FOUNTAIN WIND PROJECT

FINAL ENVIRONMENTAL IMPACT REPORT – VOLUME 2

April 2021

Use Permit No. UP 16-007
State Clearinghouse No. 2019012029

Figure 3.4-4
Spotted Owl Territories in the
Hatchet Ridge Wind Project Region

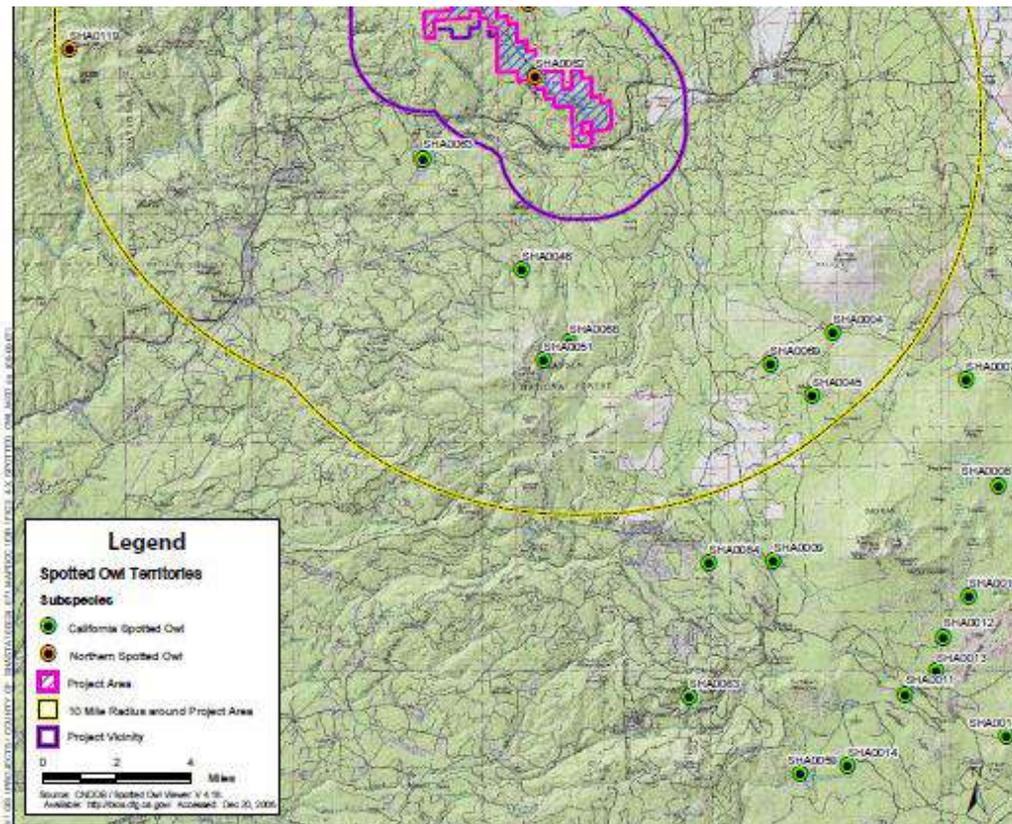
Besides the Fountain fire burning some of this owl habitat, what has happened to all these spotted owl nesting territories reported in the Hatchet Ridge EIR?

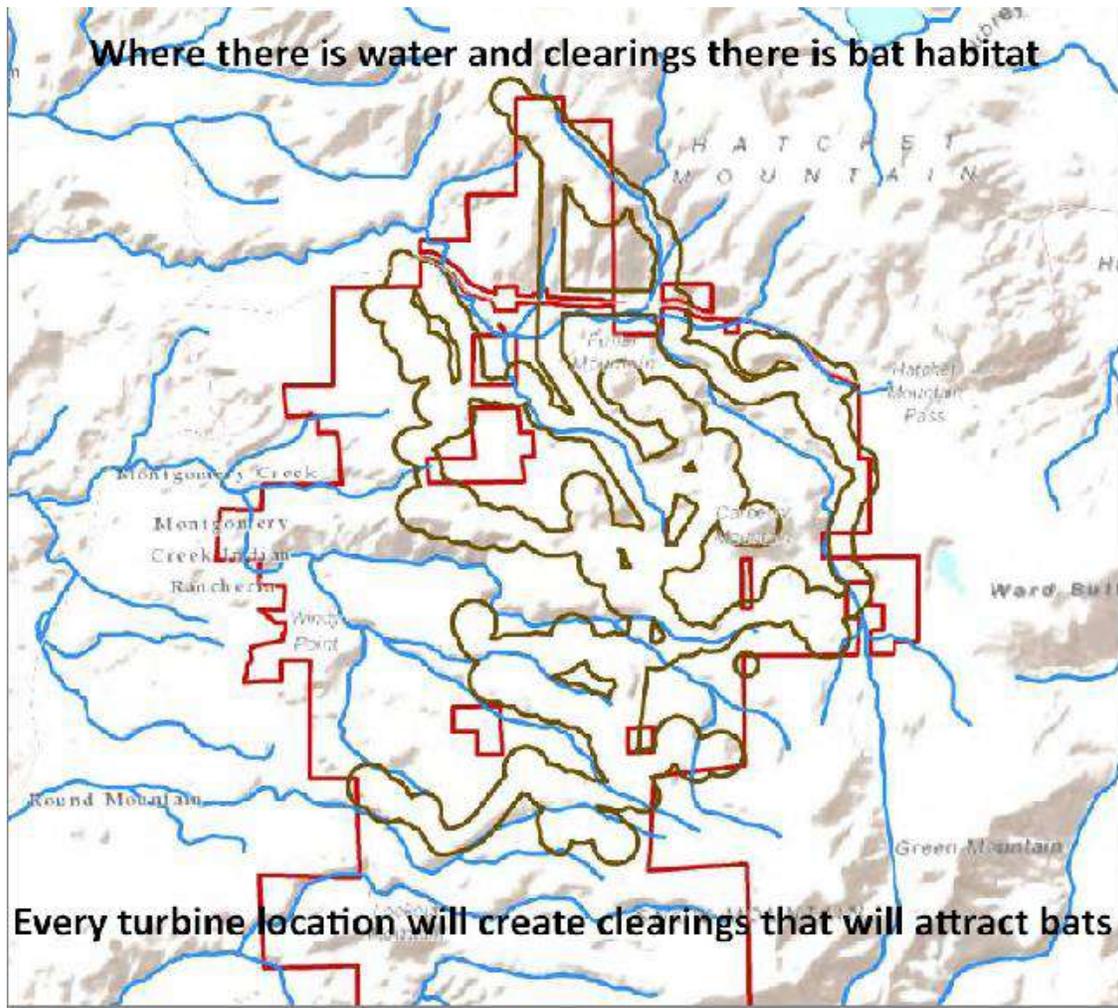
Not True - Five massive turbines will be located along this creek location (see image).

If the Bat Acoustic survey had positioned all their equipment in open areas near water with clearings, the total bat passes in this survey would have easily been several hundred thousand. The MF3g site shows this. Wind Biologists also know this and when bat surveys are conducted, they try to locate equipment away from the best bat feeding locations. I have examples that show this research pattern in other studies. Of course, the bats living near MF3g will be annihilated by at least 5 of the Fountain Wind turbines, that will be locate along this creek site.

Figure 7. Locations of raptor nests within two miles of Hatchet Ridge.

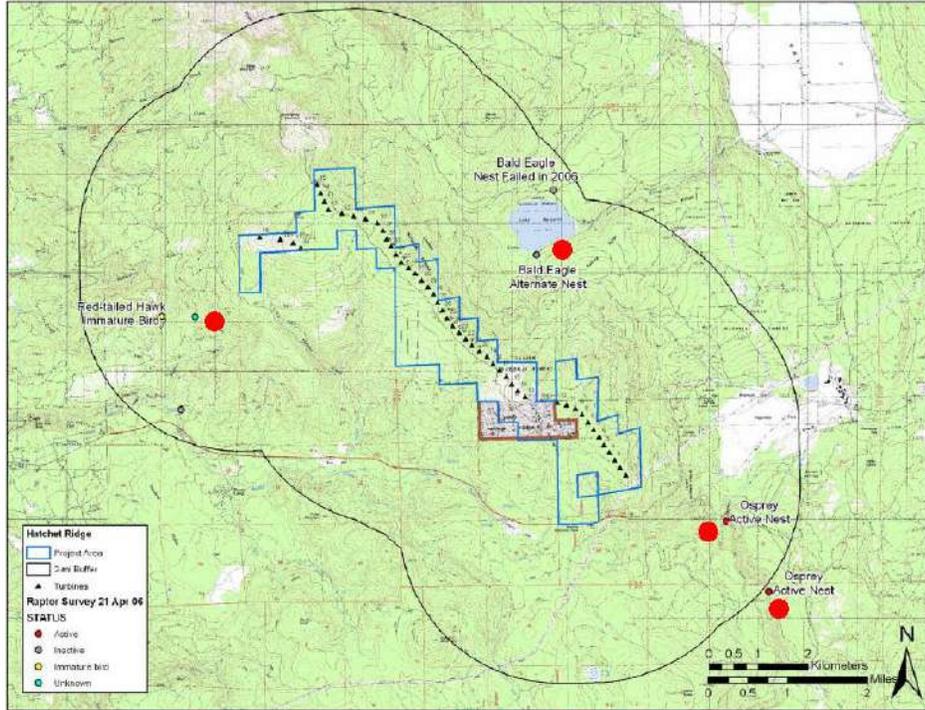
What has happened to these nesting territories since 2010 after 44 Hatchet ridge turbines became operational ???

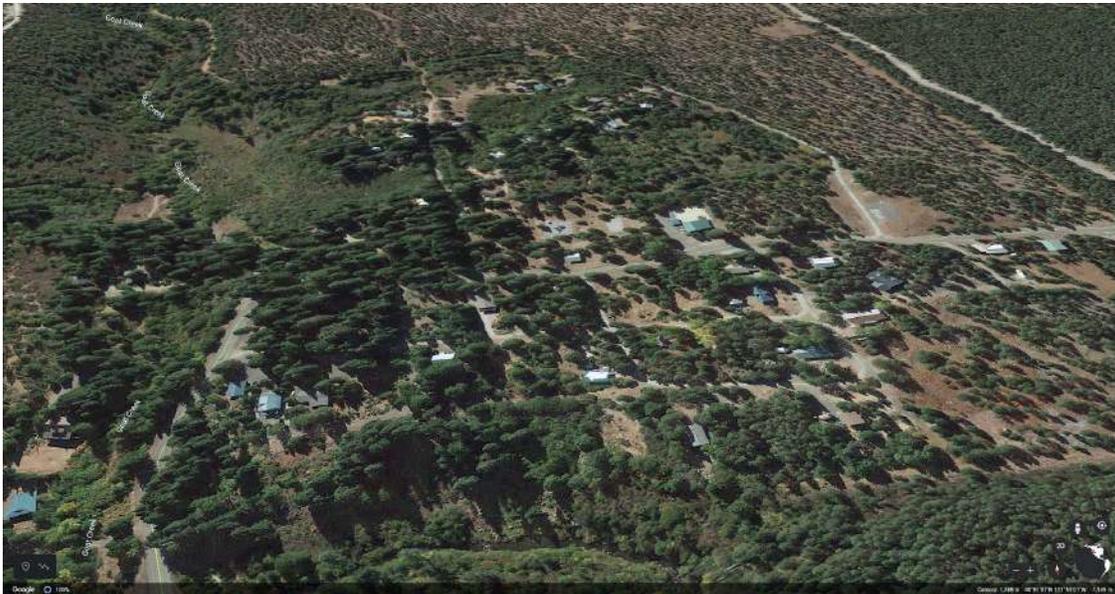
Moose Camp needs to be added as a Key Observation Point to the final EIR. Our neighborhood of 50 homes is surrounded by proposed 679 foot tall wind turbines and we are by far the closest neighborhood to turbines in the entire project. To use the rationale that we are legally structured as a private recreational camp should not be an excuse for Shasta county to ignore the visual impact of this project on a neighborhood that has existed in the county for close to 100 years.

Moose Camp is demanding the removal of proposed wind turbines (D1 - D5) - If you have ever seen wind turbines in advertisements there is never a picture of a house in front of the turbine because the vast majority of industrial wind farms are located outside residential areas. This is clearly not the case with Fountain Wind. San Diego County code required that windmills

Figure 12
 Aerial Image of Proposed
 Turbine I5
 McCloud Project
 Avangrid Renewables
 Shasta County, California

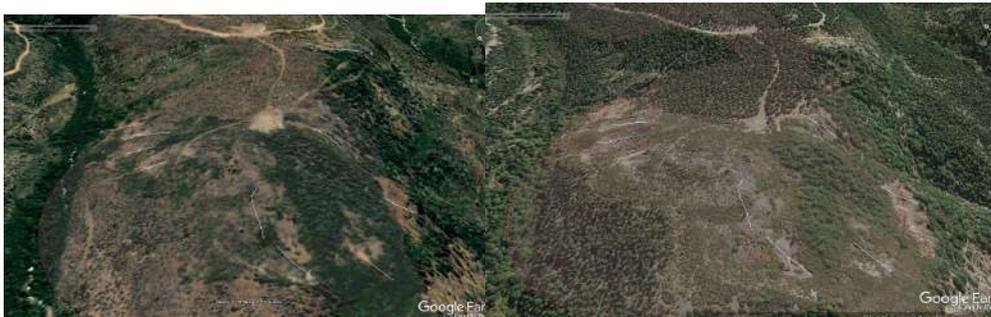
Considering that this was an obvious landslide missing from their report (though called the “McCloud Project” – is another site also being considered for future projects or was it already ruled out) I decided to look further to see if there was evidence of any other landslide, rockslide or erosion that they either chose not to look for or decided not to disclose. This is some of what I found.

The comment references a specific location at turbine "I5." However, there is no such turbine location with this attribution as shown in Draft EIR Figure 2-2. Regardless, as stated above, the analysis of landslides hazards in Section 3.9 assumes that landslide hazards are likely present at the site. As discussed on page 3.9-16, all proposed improvements, as required by law, would be subject to applicable provisions of the California Building Code (CBC). As stated on page 3.9-10 of the Draft EIR [**bold text added for emphasis**]:
